PERMIT

SEWAGE DISPOSAL SYSTEM

SUBDIVISION Middle Trail ROAD 16373 Old Frederick LOT 18D

LOT 18-D
 MIDDLE TRAIL
 LISBON FARMS
 4th Election District
 Howard County, Maryland
 Scale 1"=50'
 Date 1/21/83

PERMIT CARD

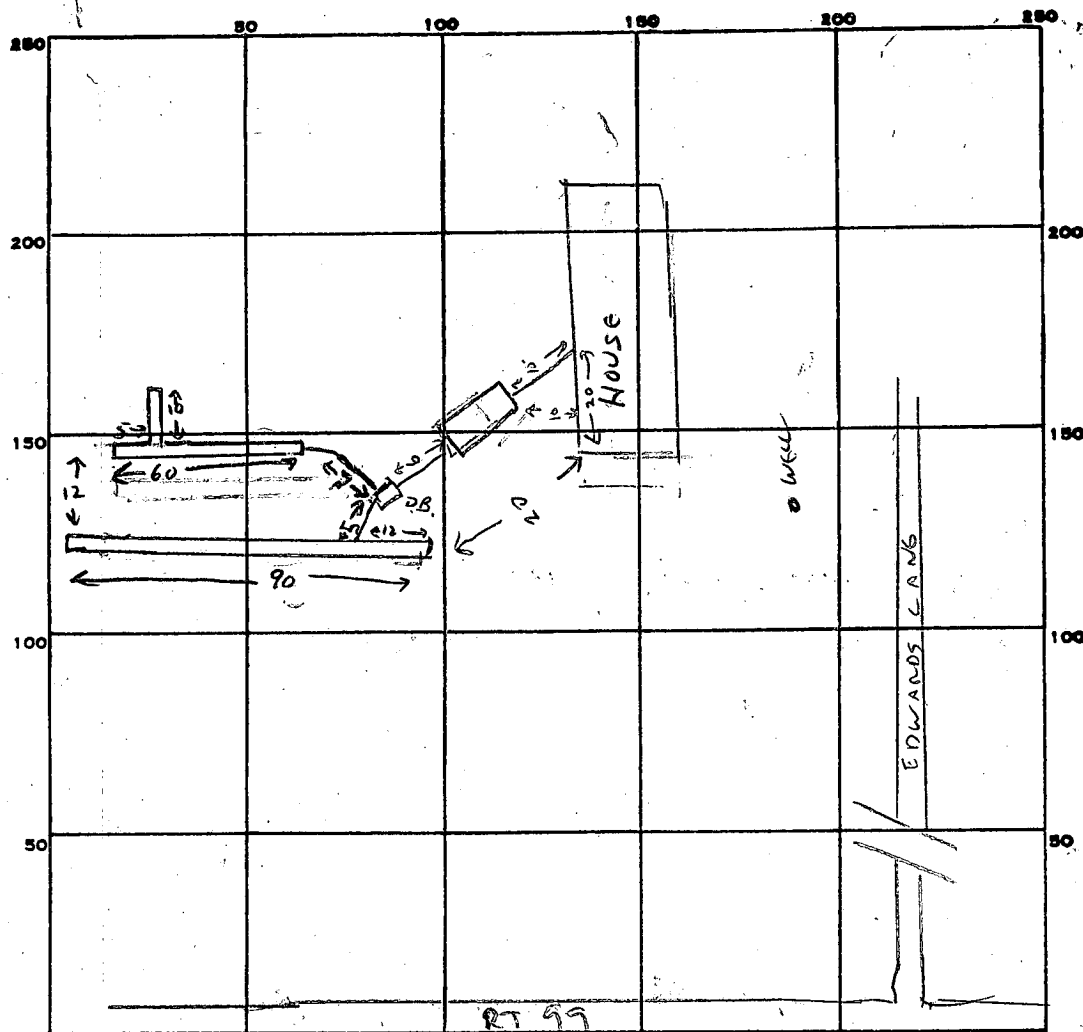
3/12/85 150 FT OF TRENCH DUG. 10 MORE FT REQUIRED ON LEVEL GROUND. CW

3/12/85 TRENCHES COMPLETE. HOUSE CONNECTION & CLEANOUT REQUIRED. CW

3/12/85 HOODUPS & CLEANOUT COMPLETE. OK TO COVER ALL WORK. CW

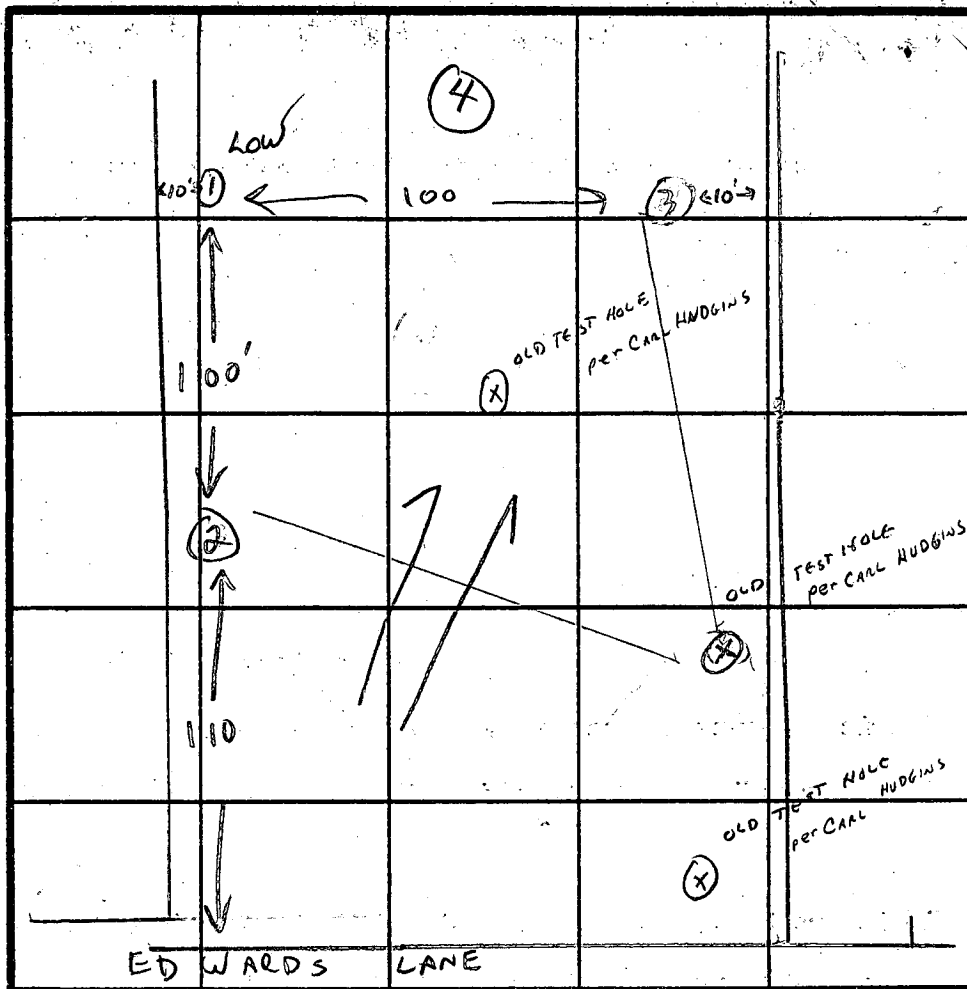
REASONS FOR REJECTION OR HOLDING SUSPECTED WATER ON LOT - SEE RESULTS FROM 18X BLDG. PERMIT SIGNED AND RETURNED *8/21/84*
- HOLD FOR WET SEASON *Serial # 60628 S.F.D.*

2/15/83 Hold for revised plat incorporating previous (1979) test hole & 1983 test hole S.F.S.
3/14/83 Plat O.K. S.F.S.

REMARKS USE NEW HOLES ON LEFT LOT LINE; OLD HOLES FROM PREVIOUS PERC ALONG RIGHT LOT LINE

PERCOLATION TEST PLAT

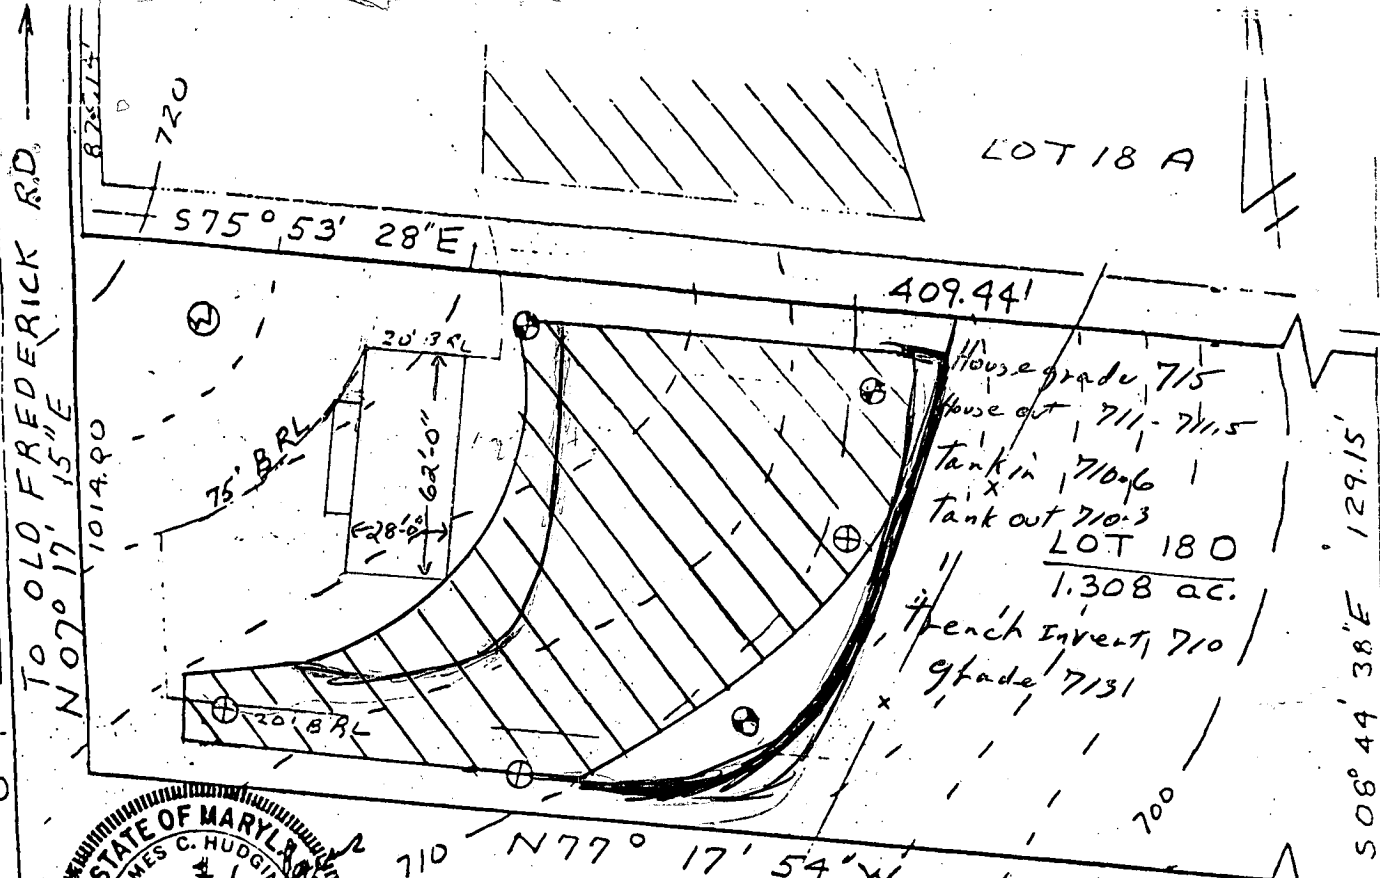
PREVIOUSLY APPROVED ELEVATION SKETCH SHOWN HOUSE OUTSIDE B.R. LINE. THIS ADJUSTMENT APPROVED AS MINIMUM INFRAINGEMENT OF RESERVE AREA WITH A PRACTICAL HOUSESITE ELEVATIONS OK
10/9/84 *Chilton*
